6875 JUANITA ST parcel 52082-24
 PLAT 871 ZONE RR-5 lot 22263 SQFT

Legal non-conforming MER166 Merger by Contiguity

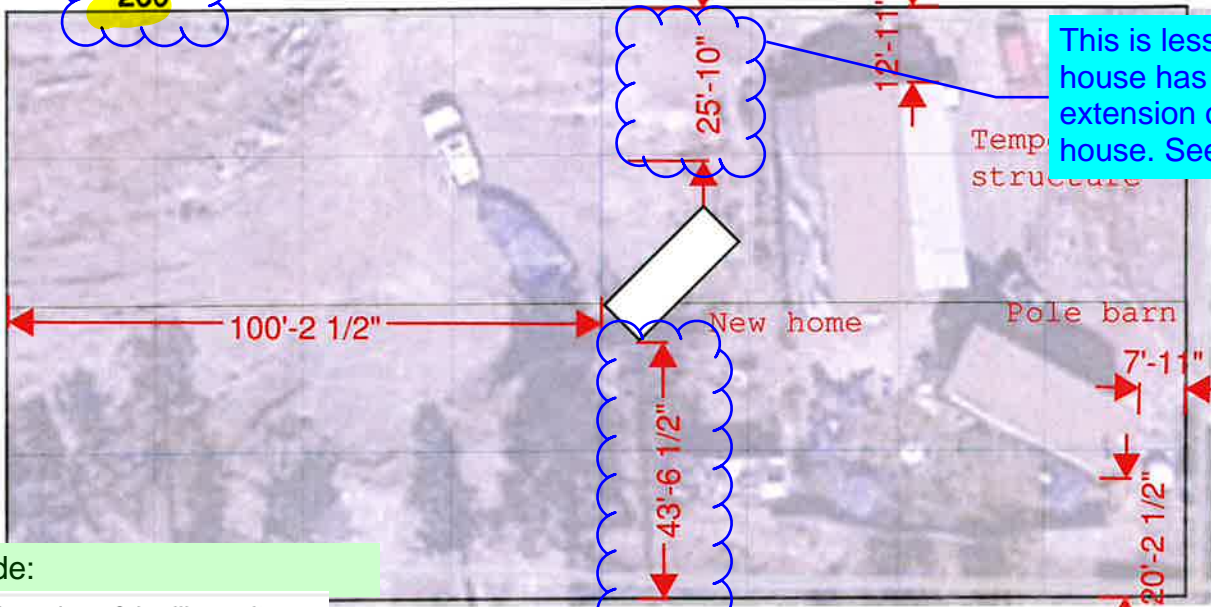
A driveway access permit will be required.

Label one (1) defined driveway with max 24ft width

Label Juanita ROW width as 20ft

Please include:

- Density and number of dwelling units
- The building footprint for all structures depicted and labeled to include the proposed use(s), floor area, and height. The setbacks of all building footprints dimensioned from all property lines.
- Location of existing and proposed water and wastewater infrastructure, including well(s) and septic system(s)
- Location of all existing and proposed utility lines and associated infrastructure
- Location and height of all fences, walls, retaining walls or berms
- Traffic circulation on site including all points of ingress/egress on the property
- Location of all no-build areas, floodplain(s), and drainage facilities

show location of septic tank, lines and field show well

This dimension appears incorrect for new structure. Depict dimensions of all structures.

A current sketch should be used instead of outdated imagery. The site plan must depict all current structures

The site plan will have to show groundcover type/ re-vegetation and grading across the lot due to extent of disturbance. Provide grading sheet or show flows arrows on an improved enlarged site plan. Show where the stormwater is being directed. A drainage letter and/or a grading sheet may be needed due to extensive lot disturbance
